TOWN HALL RENOVATIONS - ADDENDUM 04

ADDENDUM NO. 04

Project: BERLIN TOWN HALL & ANNEX RENOVATIONS

Project No.: 2024-41

TOWN HALL EXISTING 1ST FLOOR		TOWN OF BERLIN TOWN HALL & ANNEX	
		ATTN: MAYOR & COUNCIL OF THE TOWN OF BERLIN 10 WILLIAMS ST. BERLIN, MD 21811	
Project number	2024-41	Drawn by	SKA-04
Date	01.06.2026	Checked by	DNH
Drawn by	DNH	Checked by	DNH
Scale	3/32" = 1'-0"	Scale	1'-0"

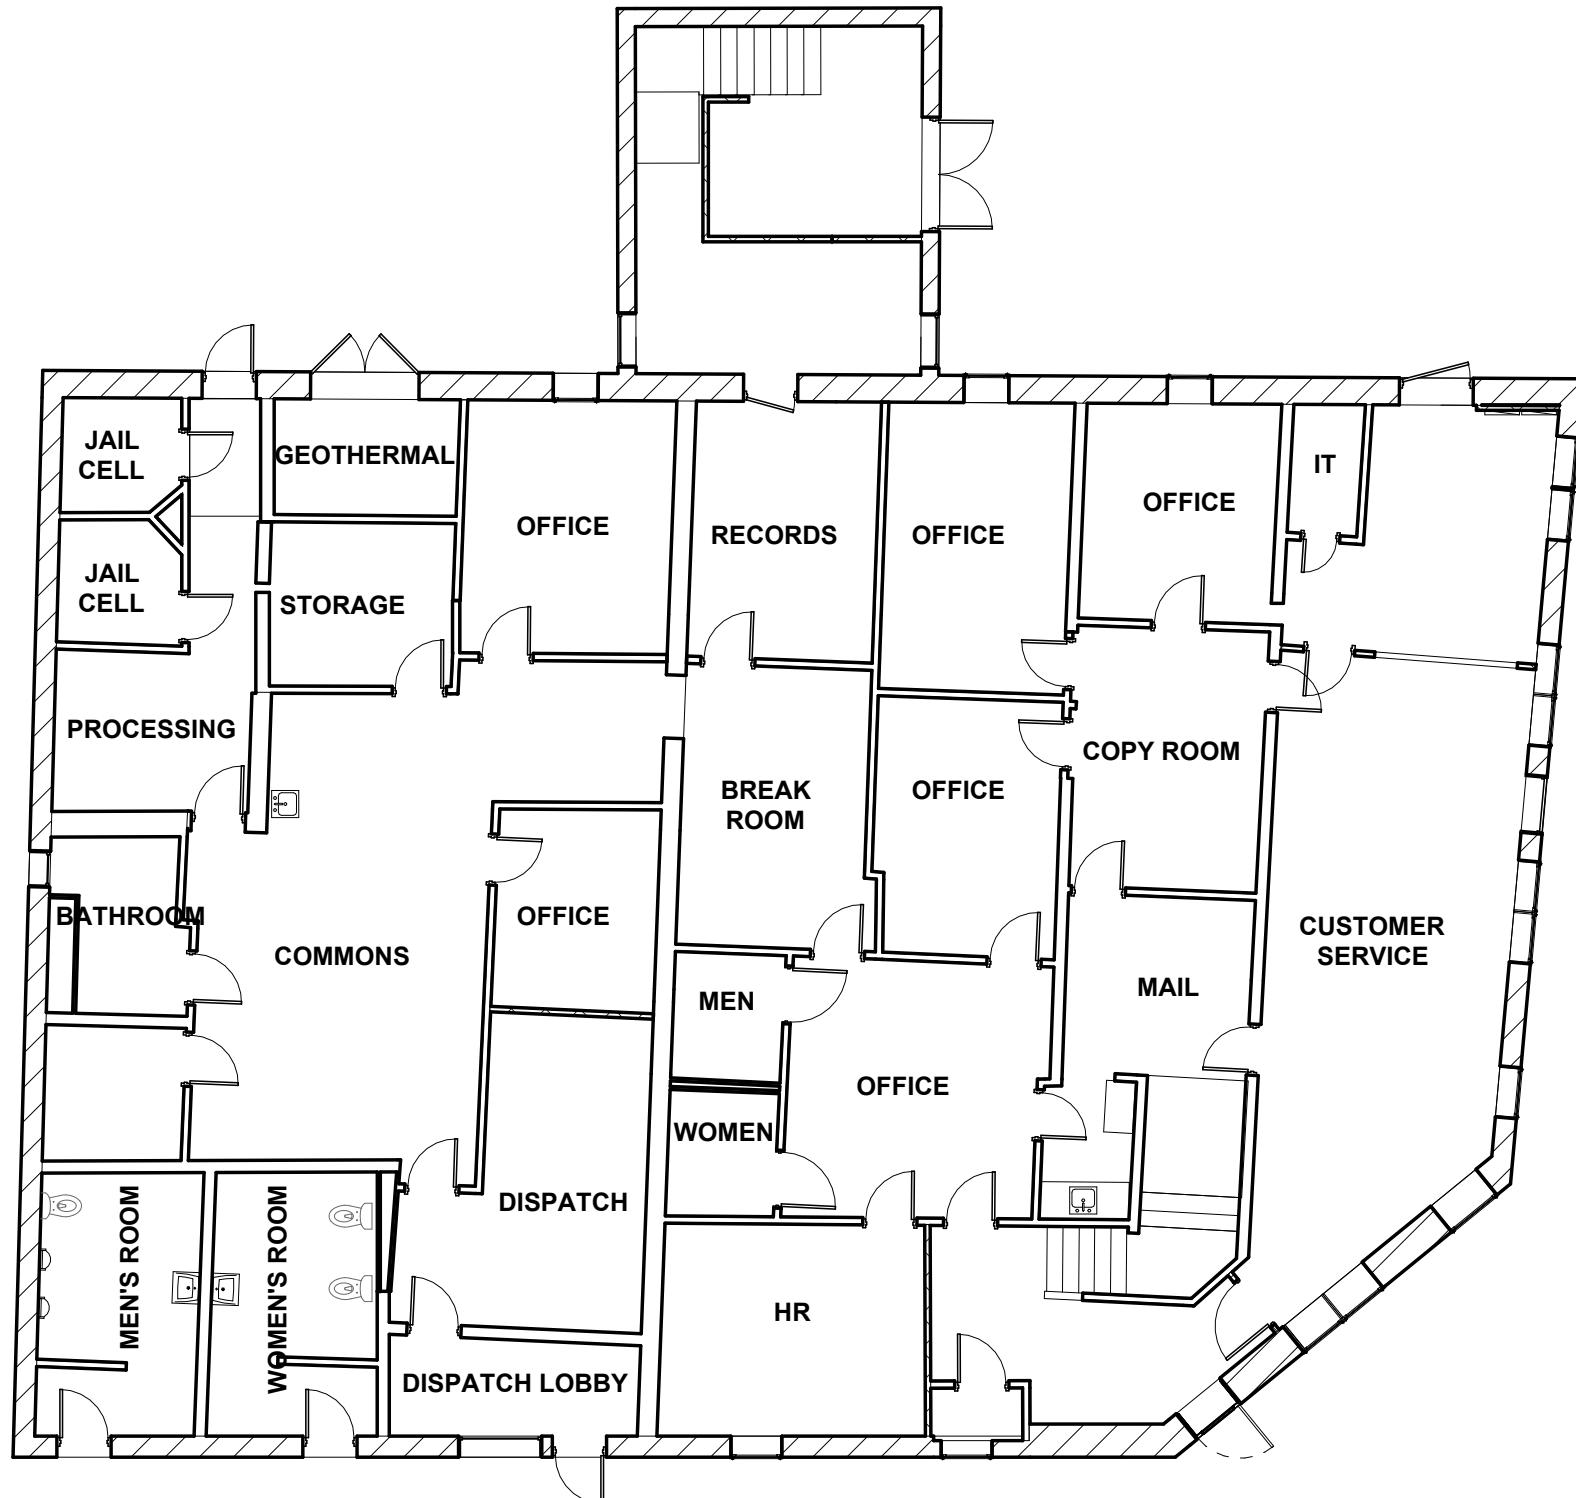
7. **QUESTION:** The asbestos report sample location names do not align with the room names shown on the architectural drawings. Please clarify which rooms on the plans correspond to the reported asbestos test results.

ANSWER: SEE ATTACHED SKETCHES SKA-04, SKA-05, & SKA-06 FOR EXISTING ROOM NAMES FOR COORDINATION WITH ASBESTOS AND LEAD REPORTS.

MAIN ENTRY 100- ENLARGED FLOOR PLAN (CT-PATTERN)

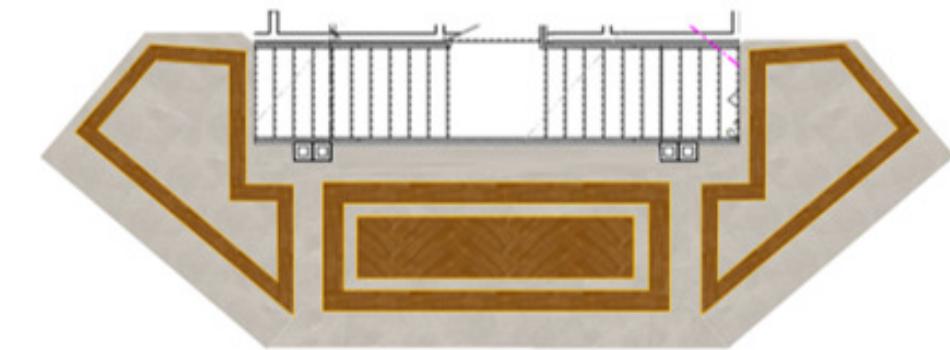
- REVISE SHEET E301 TO INCLUDE NEW DISCONNECT SWITCH
- REVISE SHEET E801 TO INCLUDE NEW DISCONNECT SWITCH
- REVISED FINISH SCHEDULE ON SHEET I-601 PER SKI-02 & SKI-03 (ATTACHED)
- REVISED ENLARGED FLOOR PLAN ON SHEET 1-411 PER SKI-04 (ATTACHED)

ELECTRICAL - LEVEL 01 PLAN - POWER/ SYSTEMS - TOWN HALL

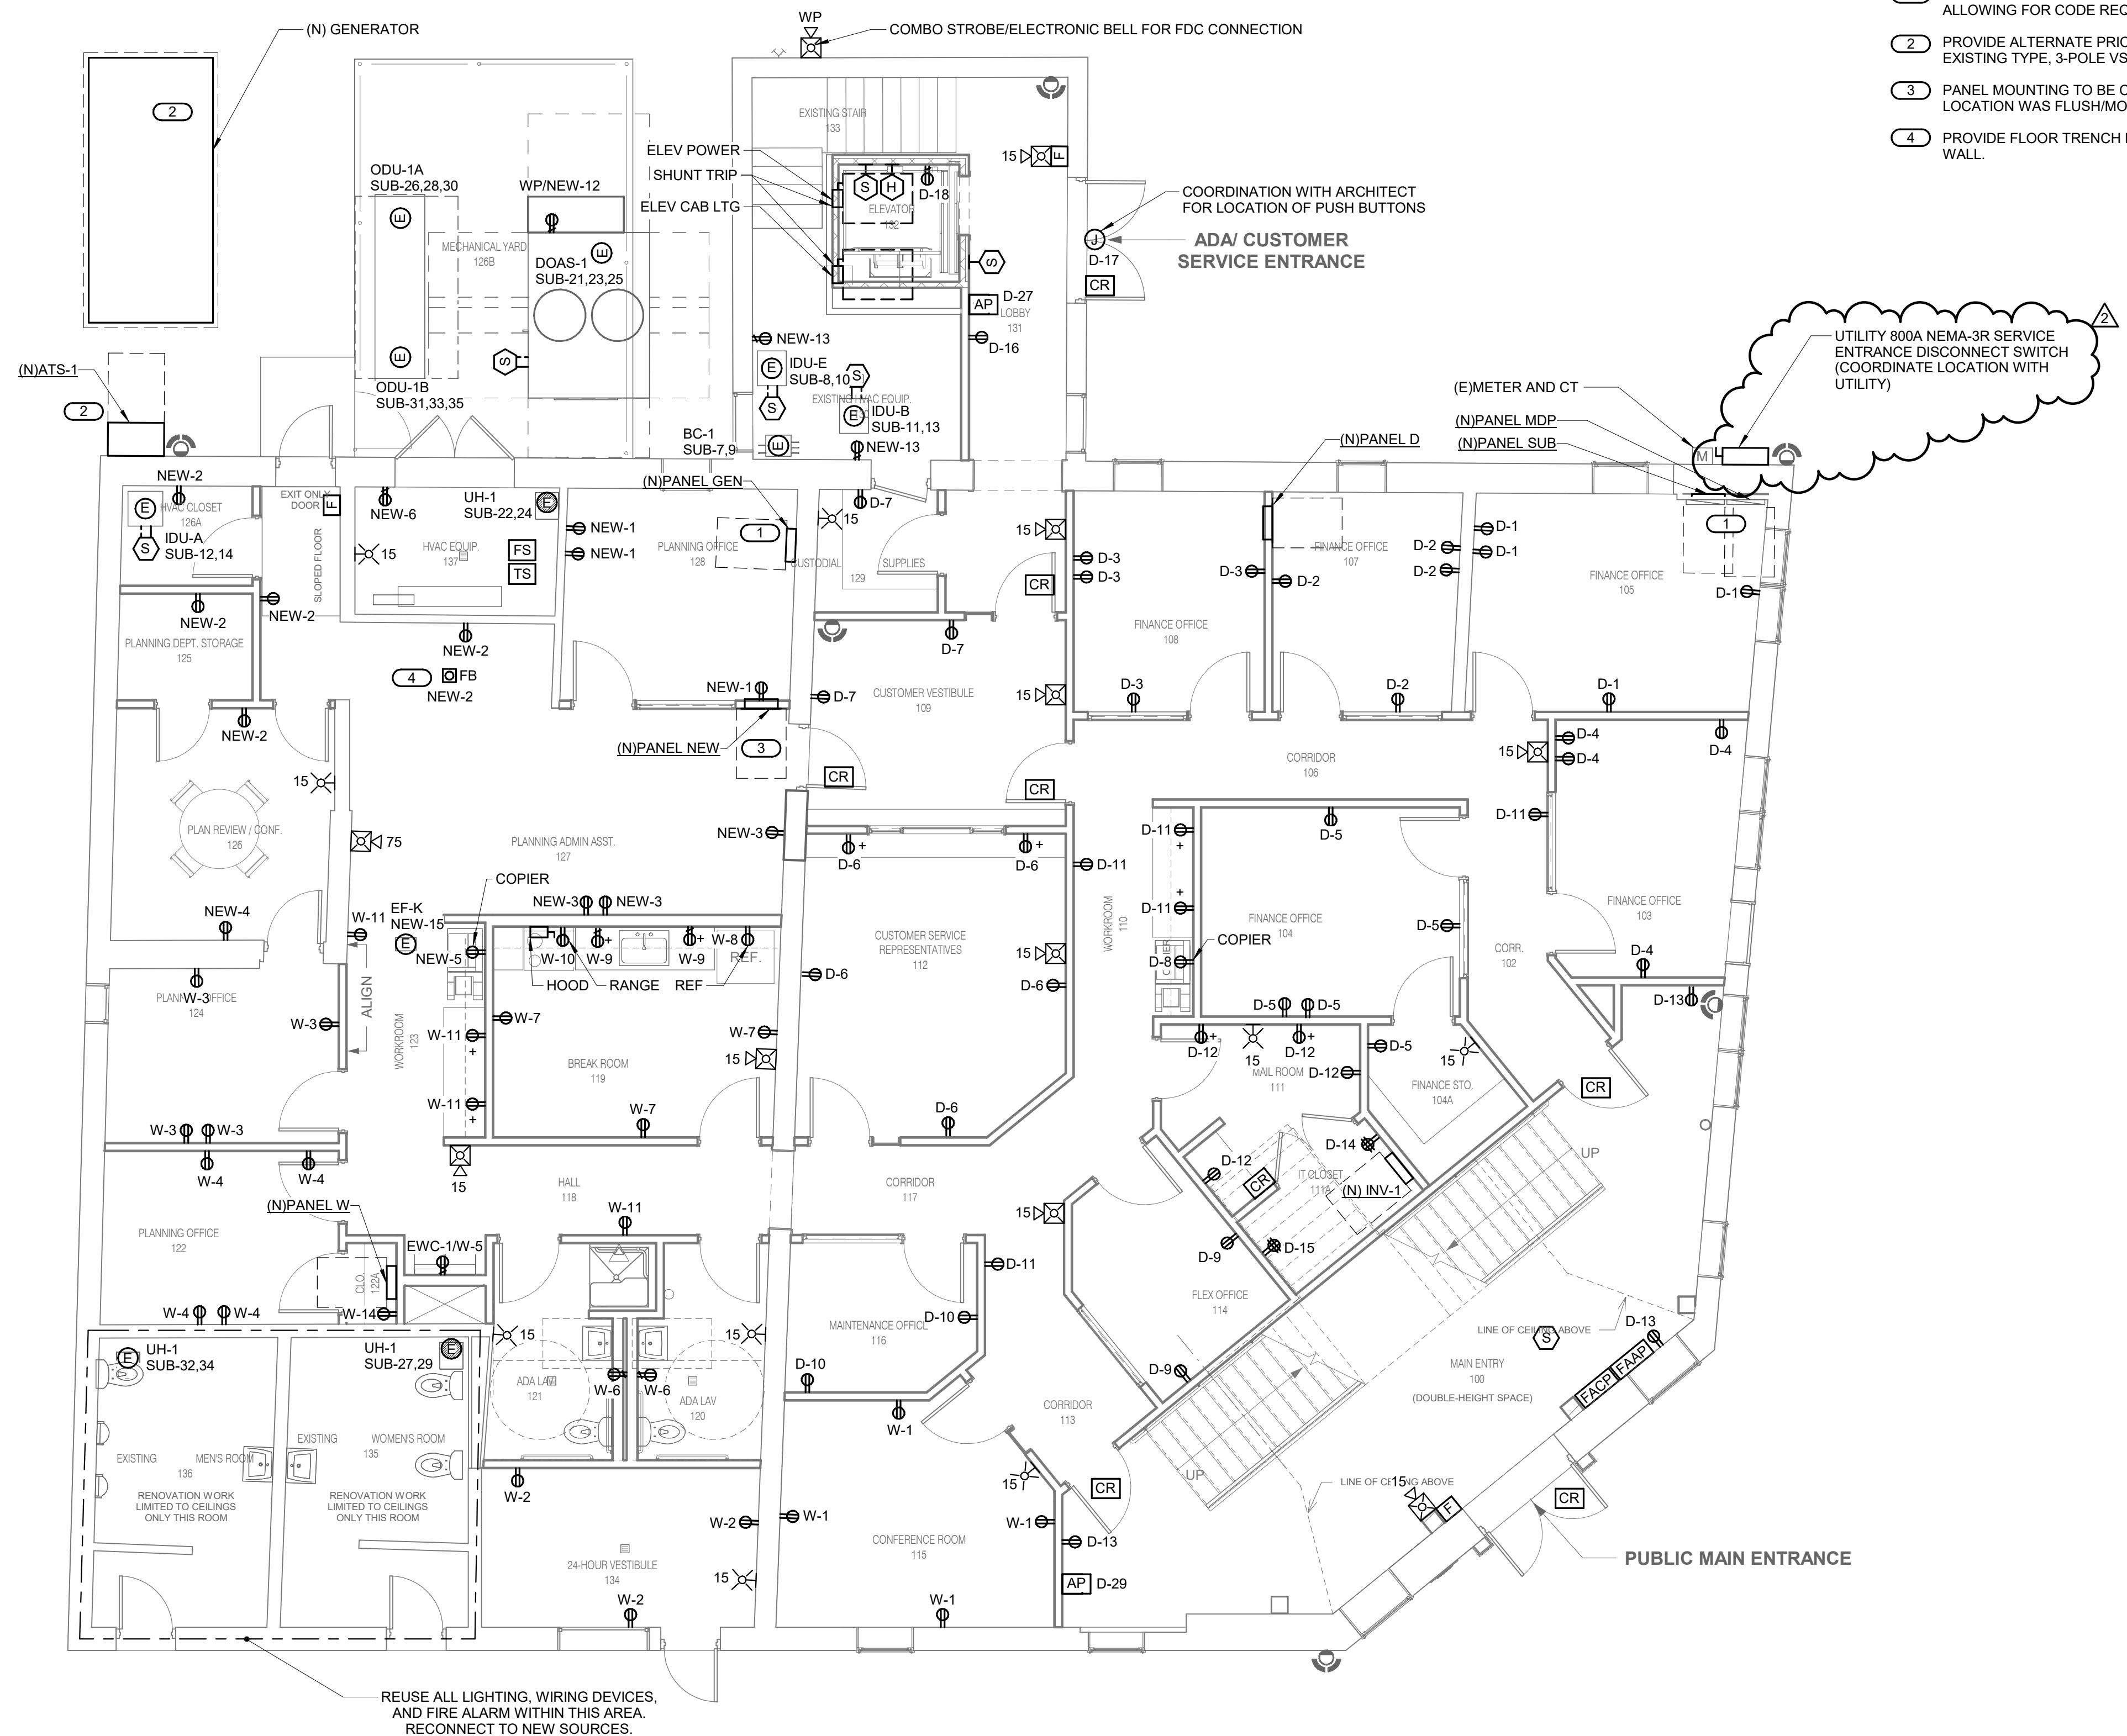
4. **QUESTION:** Can an extension be added for RFI's or the bid date to accurately answer and estimate the service entrance requirements? Impressions from the Utility company are that a service disconnect will be required; however, we are still waiting for feedback due to the holidays. One concern is that with the door being removed, the panel mains will not be easily accessible in the event of an emergency. Secondly, if the fire department enters the building and shuts down the MDP panel, they will not know to also shut down the SUB panel, and all the HVAC loads will still remain energized, which creates a safety concern.

ANSWER: NO EXTENSION WILL BE ADDED. SEE REVISED SHEETS E301 AND E801 FOR NEW DISCONNECT SWITCH.
